MEMO TO: Parvati Rotherham CC: Dan Kellow [2/5; 7/8; 19/8; 23/9/19]

FROM: David Wanty, Wanty Transportation Consultancy; CPEng, M.ITE

RM190124: Eastern Bays shared path (also RM WGN190301 re GRWC).

ISSUE DATE: 9/05/2019 REVISED: 19/8/19; 23/9/19 SITE VISITS: 2/5/19

Figure 3-11: Coastal Edge Treatment

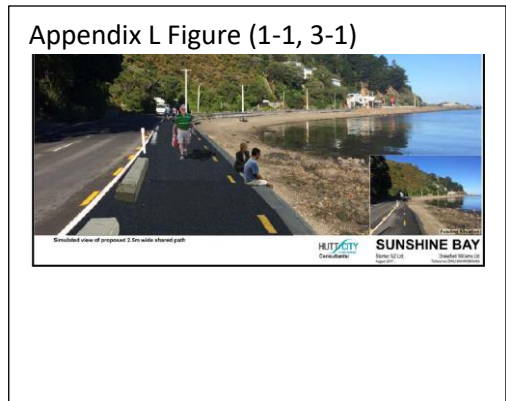
A key matter of concern is that there is no barrier or additional width along the 2.5 m sections of the shared path on the seaward side with a drop of more than a metre to the beach, which means that the design does not meet a key requirement to afford protection to users (even though the existing situation similarly fails).

However the proposed “concrete coastal edge treatment” does not include any vertical element, preventing an errant skateboard or e-scooter for example (or their user) from going into the sea.

The height of the kerb separators was not dimensionalised but is understood to be 150 mm. As this is corresponds to the pedal clearance of my 26” mountain bike they should preferably be lower since if inadvertently struck a rider could potentially be thrown out of alignment or even over the edge.

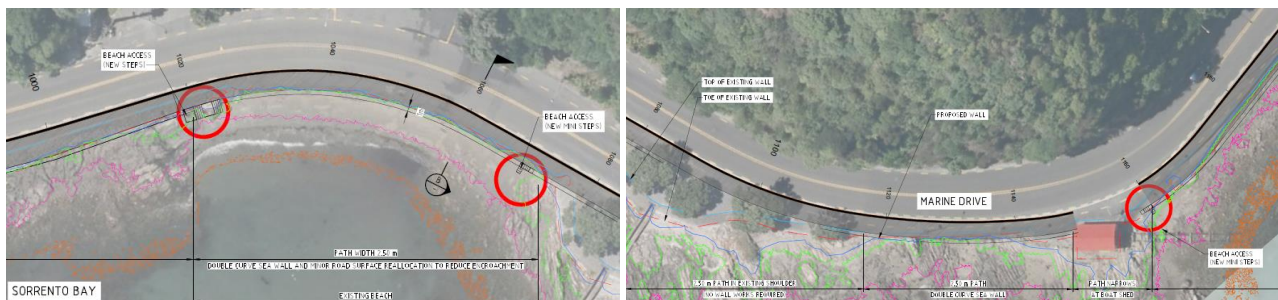
Comparing with my table (some path widths corrected) and sections of double or triple curve (generic presumed drop-off more than 1 m) not included above, comprise as follows:

- 705-1000 3.5 m, double curve (295 m)
- 1010-1080 2.5 m, double curve (70 m)
- 1115-1150 2.5 m, double curve (35 m)
- 1260-1365 2.5 m, double/triple (105 m)
- 1410-1535 3.5 m, double/triple (125 m)
- 2275-2330 3.5 m, double curve (in effect a 55 m extension to the York Bay north section)
- 2420-2570 3.5 m, double curve (in effect a 150 m extension to the York Bay north section)
- 3035-3340 3.5 m, double curve (305 m)
- 3470-3530 3.5 m, double curve (a 60 m extension to Between Mahina & Sunshine section)
- 3690-3910 2.5 m, double curve (a 230 m extension to Between Mahina & Sunshine section)

From the above it is clear that there are four potential sections with drop-off exceeding 1 metre that have less than 3.5 m width, contrary to what Stantec have stated.

A full height barrier of 1100mm is proposed at four locations where the drop-off is greater than 1 metre, which is estimated as a total of between 700-800m of the shared path. The final location and lengths will be confirmed during the detailed design.

- Gill Road to Whiorau Reserve: ST1790-1955 (3.5m wide path) [165 m, double curve, 3.5 m]
- York Bay north: ST2330-2420 (3.5m wide path) [90 m, double curve, 3.5 m]
- Between Mahina & Sunshine: ST3530-3680 (3.5m wide path) [150 m, double curve, 3.5 m]
- Windy Point: ST5050-5395 (3.5m wide path) [345 m, double/triple curve, 3.5 m]

The design of the barrier or railing will be confirmed during detailed design. It will meet the Code and will be of a durable material to withstand the coastal conditions.

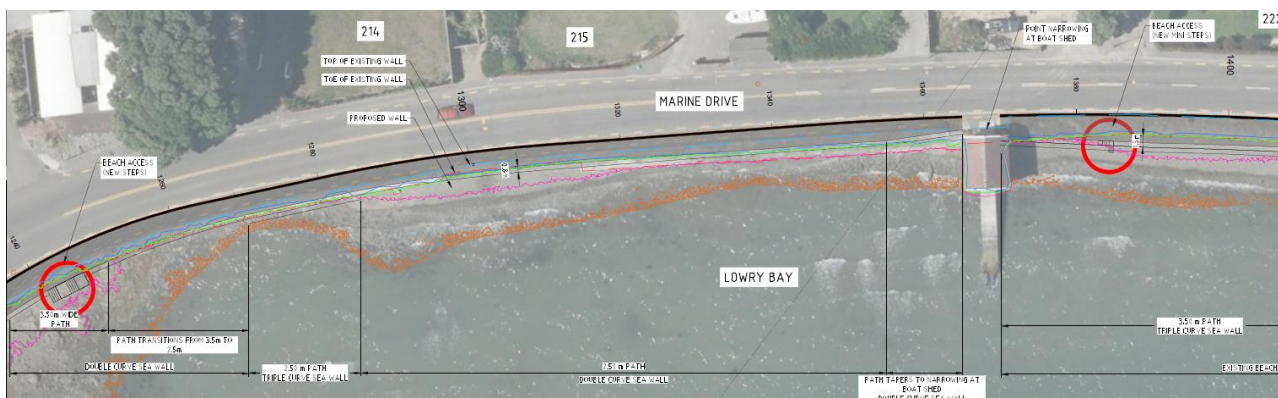
The Sorrento Bay section (refer cross section B) and north of the boat shed are likely to have a drop-off exceeding 1 metre so these two sections should be included in the first instance and should thus be widened to accommodate the safety barrier while retaining at least 2.5 m path width.

The Lowry Bay section from the proposed steps to the existing boat shed is likely to have a drop-off exceeding 1 metre so this section should be included in the first instance and should thus be widened to accommodate the safety barrier while retaining at least 2.5 m path width.

Cross section J at CH3740 reveals the drop-off is more than 1 metre and so this section should be included and should thus be widened to accommodate the safety barrier while retaining at least 2.5 m path width.

Figure 4-1: Eastern Bays (Point Howard) - Observed Cyclists Volumes 2017 (tube count survey)

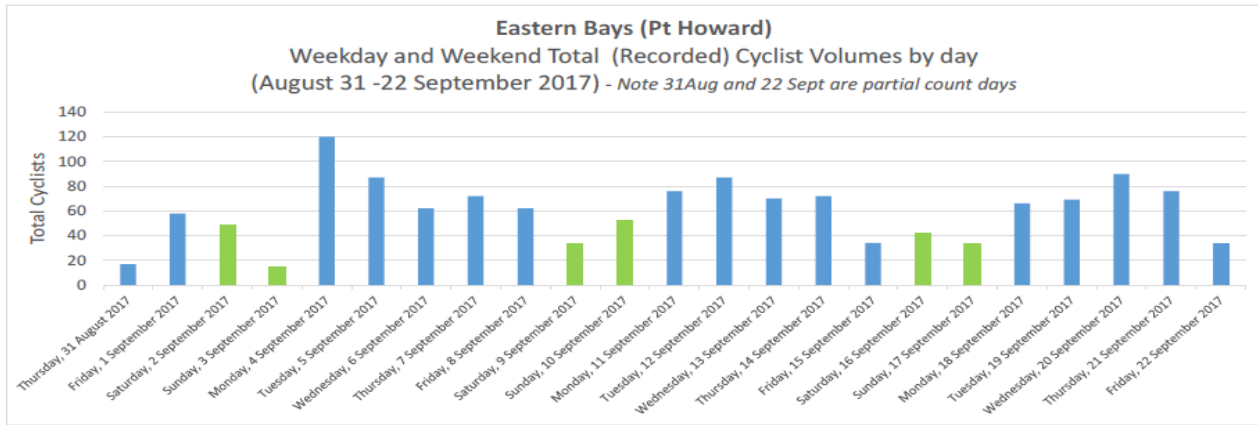
These daily flows when converted to peak hour flows would seem to suggest from Figure 4 that a shared path width of 2.5 m is sufficient (in a favourable situation) from a convenience viewpoint.

Despite that fact that widening to 3.0 m might be the same in cost as widening to 3.5 m, it presumably will result in less beach encroachment than 3.5 m, so considering all of the above (and further points below) it would seem reasonable to design for a 2.85 m minimum width which will allow inclusion of a barrier/fence (Council will consider edge kerbing or low fence at detailed design stage and hopefully seek independent expert advice if a “fall from height” barrier is required or not to meet the Building Code) along the seaward edge where a double or triple curve seawall is provided. Where there is revetment treatment an edge barrier/kerb (presumably with drainage slots) should be provided, noting also the WSP Opus idea that the concrete edge could be 0.35 m as a visual warning and such a width should be sufficient to accommodate a barrier and a slight additional shy line width provision (the separator kerbs are 0.30 m wide and probable 0.15 m high – same as an adult bicycle pedal clearance).
